Addendum No. 1

Contract ID: C200691 (Proposal No.2)

Work Order No. 8.U401727 F. A. No. NHF-540 (2) Wake County (R-2000F)

I-540 (Northern Wake Expressway) From East of

SUPERSTRUCTURE TYPICAL SECTION

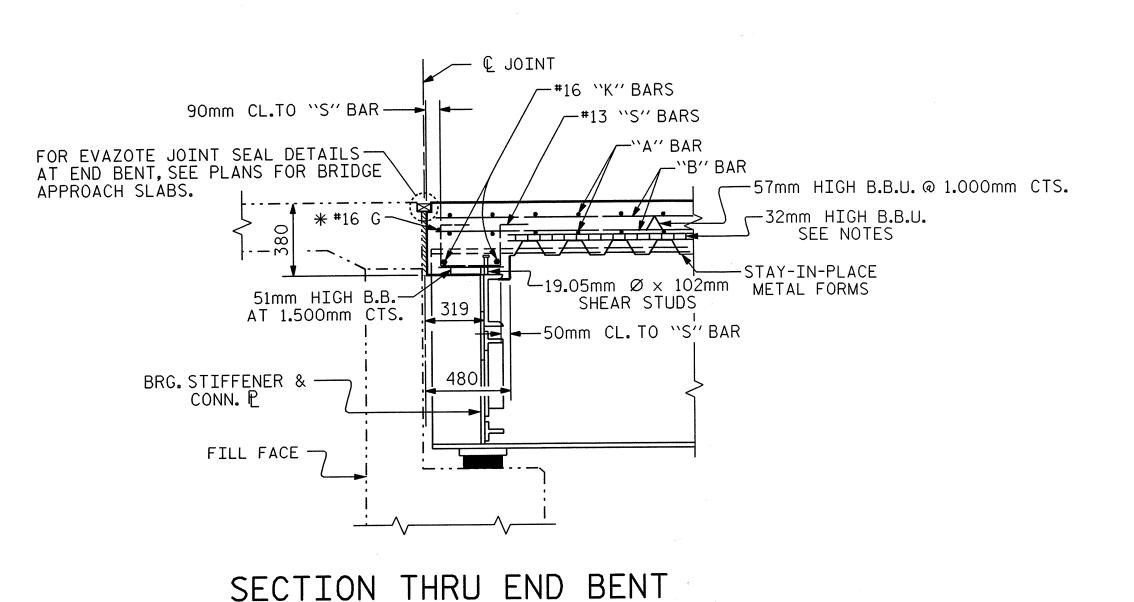
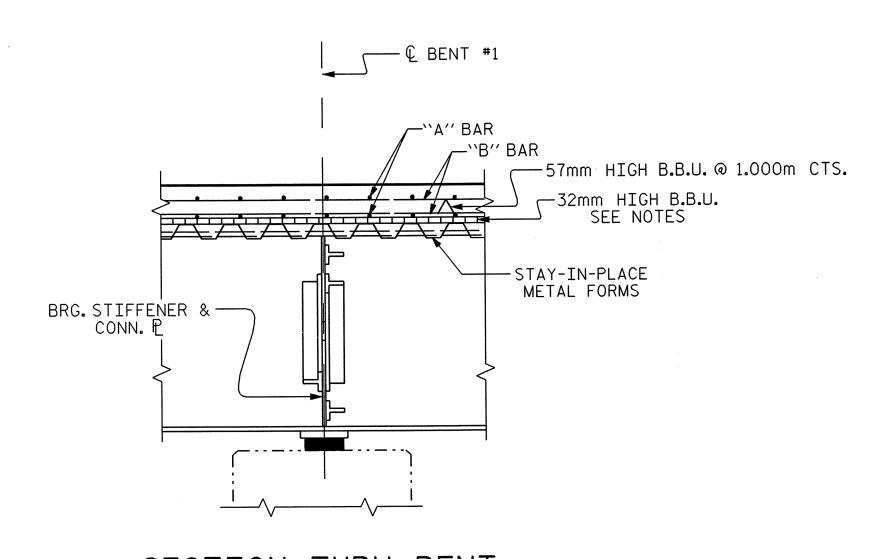
On sheet no. S-47, the reference to "Sand Lightweight Concrete" in the PVC deck drain note has been revised. Please void sheet no. S-47 in your plans and staple the revised sheet no. S-47 thereto.

PVC DECK DRAINS SHALL BE PAINTED WITH TWO COATS OF BROWN PRIMER MEETING THE REQUIREMENTS OF ARTICLE 1080-12 OF THE STANDARD SPECIFICATIONS. EACH COAT SHALL BE 0.050mm THICK. DECK DRAINS SHALL BE ROUGHENED PRIOR TO PAINTING. NO SEPARATE PAYMENT SHALL BE MADE FOR PAINTING PVC DECK DRAINS AS THIS IS CONSIDERED INCIDENTAL TO PAY ITEM FOR REINFORCED CONCRETE DECK SLAB.
